Stage 1 Road Safety Audit

MINERS ROAD
LLAY
WREXHAM

STAGE 1 ROAD SAFETY AUDIT

Ref: 21-119-001.02

Title: STAGE 1 RSA LOCATION PLAN

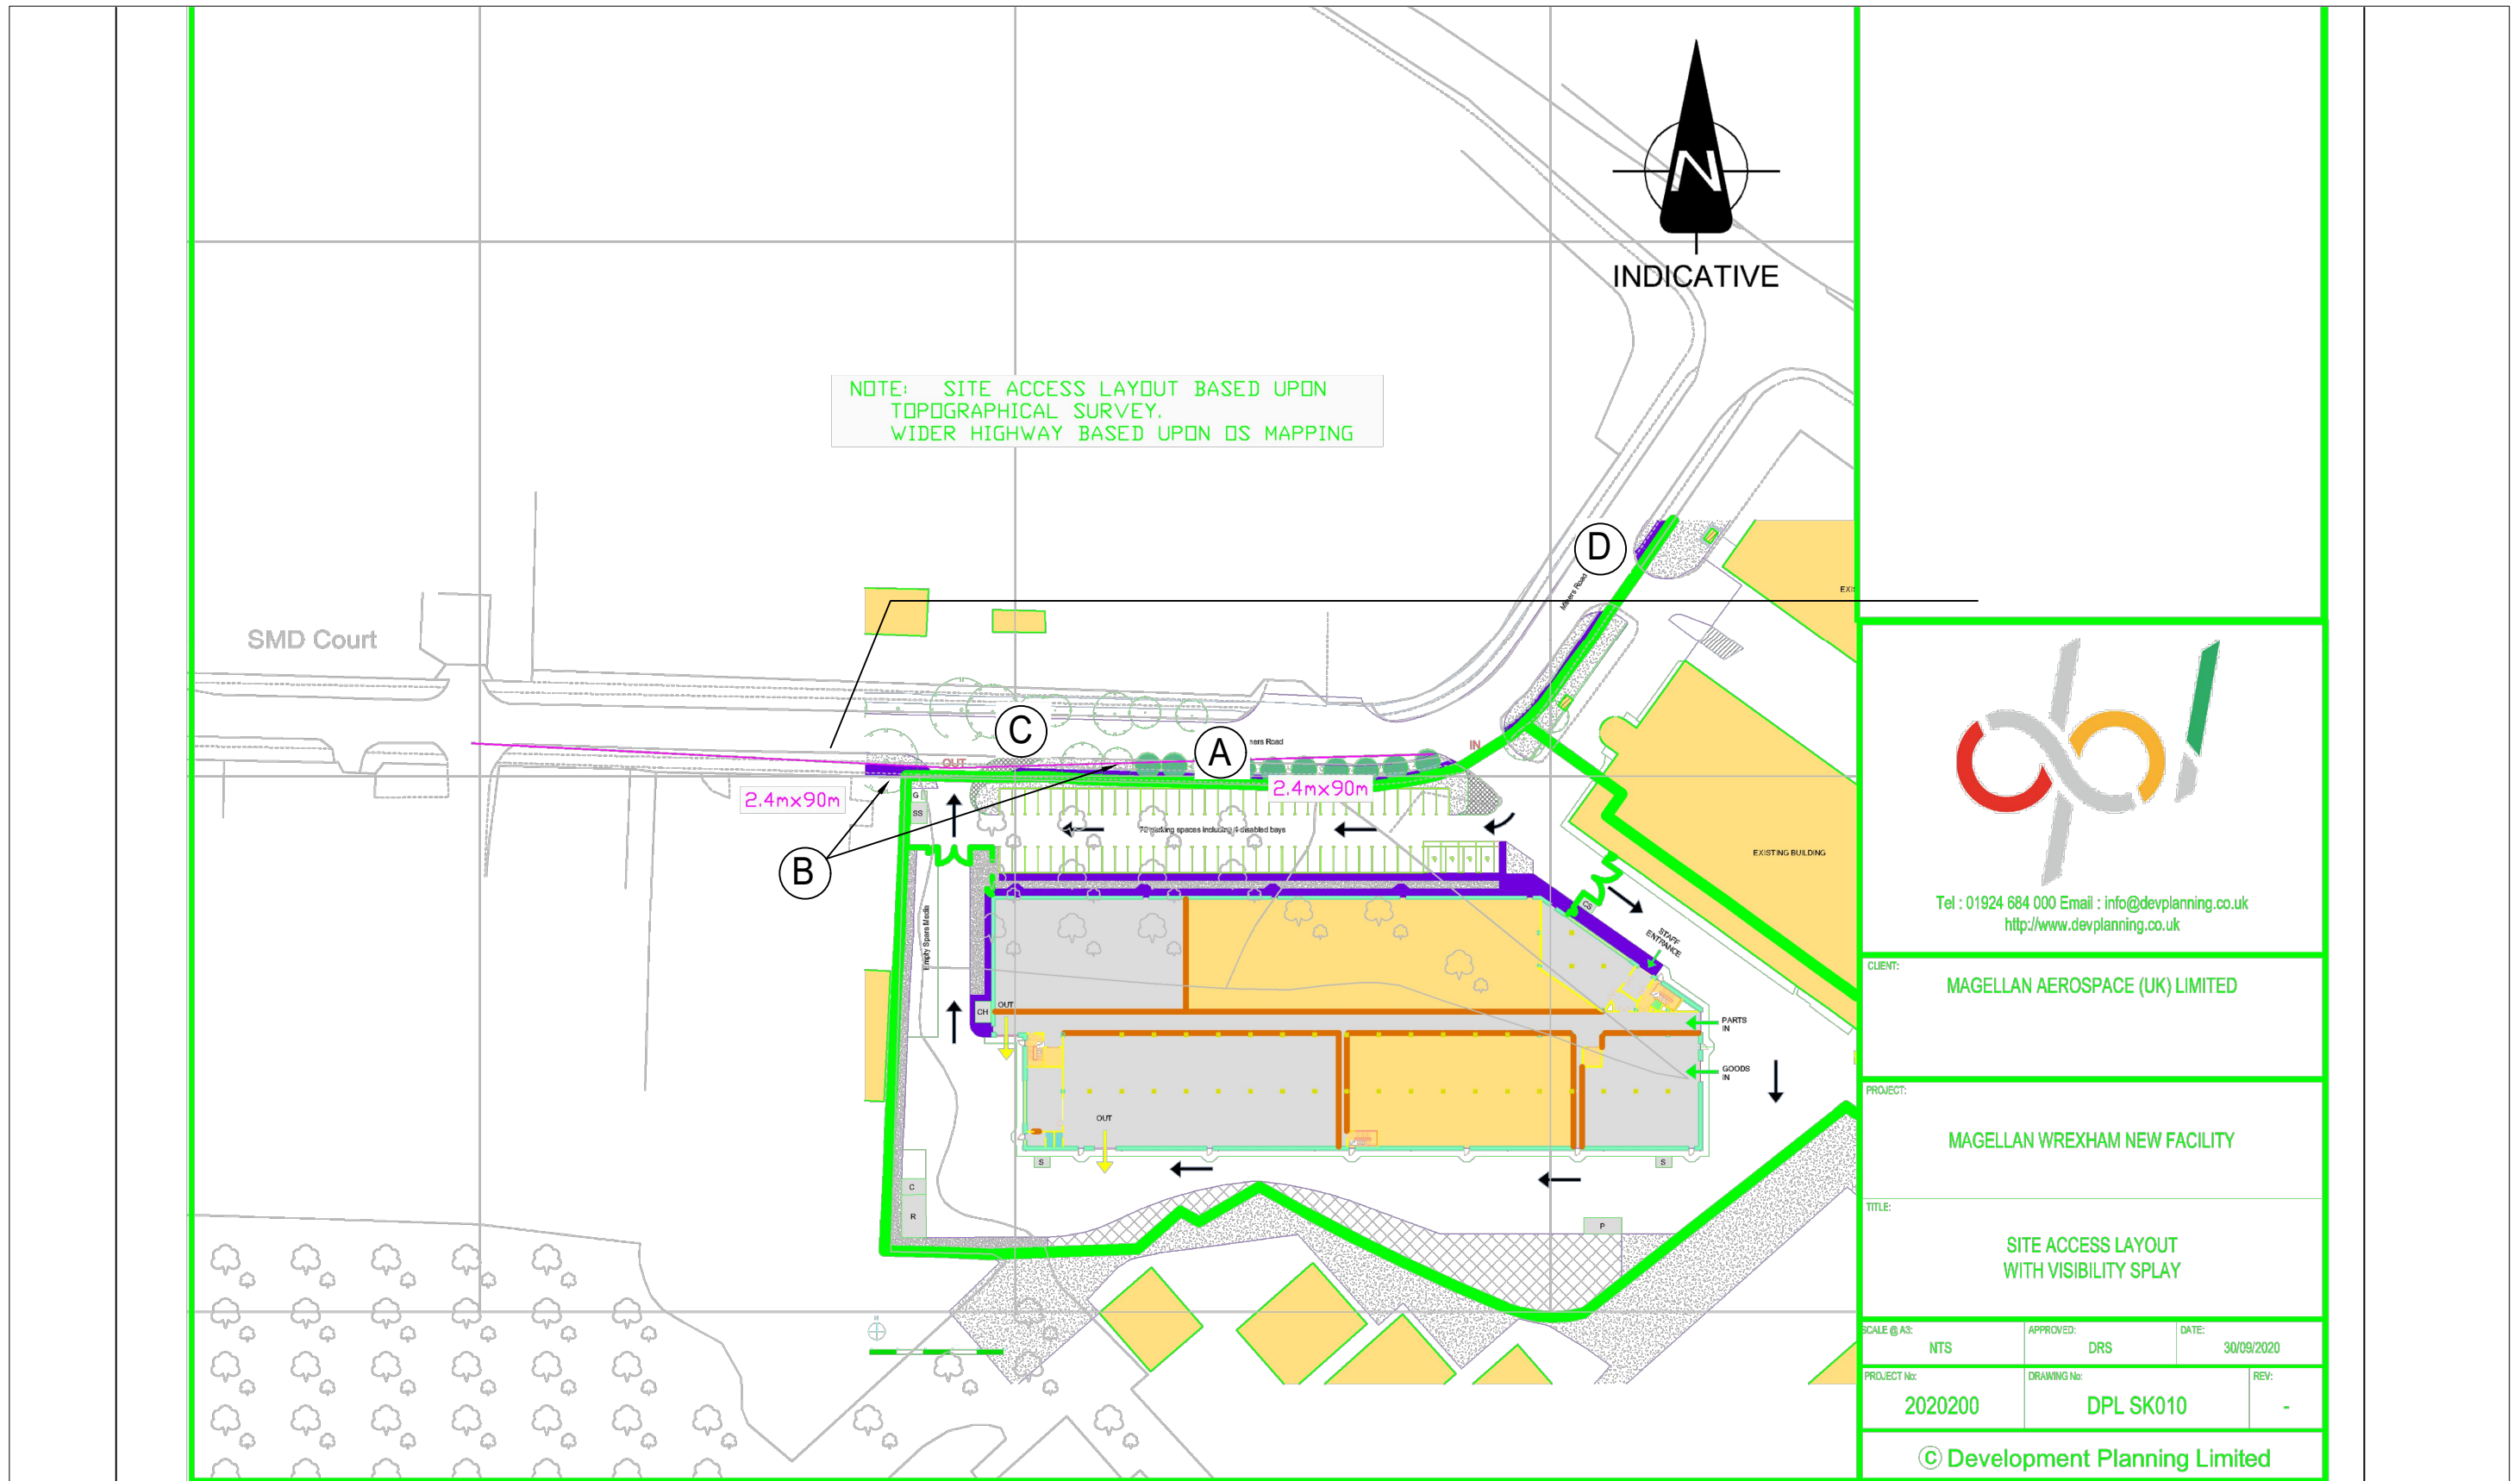
- 2.1 All items raised within this Stage 1 RSA are shown on the annotated plan at **Appendix BGH1**.

- 2.2 HGV parking on Miners Road in the vicinity of the proposed exit only junction.

The length of HGV parking on Miners Road result in the effective carriageway (in close proximity of the proposed exit) being reduced to shuttle type running along the proposed site frontage. This could result in a number of difficulties in respect to road safety, such as:-

- 2.3 Visibility from proposed egress.

Driver visibility to oncoming vehicles from the proposed exit only junction appear to be obscured by existing trees and street furniture on Miners road. This matter is compounded by the issues raised in Problem A. An example of this is shown in the photographs at **Appendix BGH2**. Because of this, emerging drivers may not have sufficient sight of oncoming vehicles, resulting in drivers entering Miners Road when it is inappropriate to do so and increasing the likelihood of collisions as the driver leaves the site.

- 2.4 Pedestrian movements across proposed exit only access.

The proposed egress is excessive in width and includes a hatched area which allows for the swept path / over running of larger HGV's when leaving the site. The excessive width will result in longer crossing times / exposure to vehicles.

The hatched area may also be misconstrued as a safe area for pedestrians to use as a refuge when waiting to cross the egress. It will not just be HGV's utilising the egress and all vehicles will be permitted to utilise the full width of the egress when leaving the site. This may lead to an increase in the potential for vehicle to pedestrian type incidents.

Demonstrate the existing on street HGV parking is not detrimental to the operation of the proposed access and egress arrangement. For example, through further swept path analysis, plotting of forward visibility splays on the link etc. Should it be found that the parking effects the proposals, measures should be introduced to reduce the potential for conflict between vehicles on Miners Road.

Ensure there are no physical obstructions to the required visibility envelope from the proposed egress to approaching vehicles on Miners Road.

Ensure the egress arrangements accommodate all modes of travel, including measures to aid vulnerable users cross.
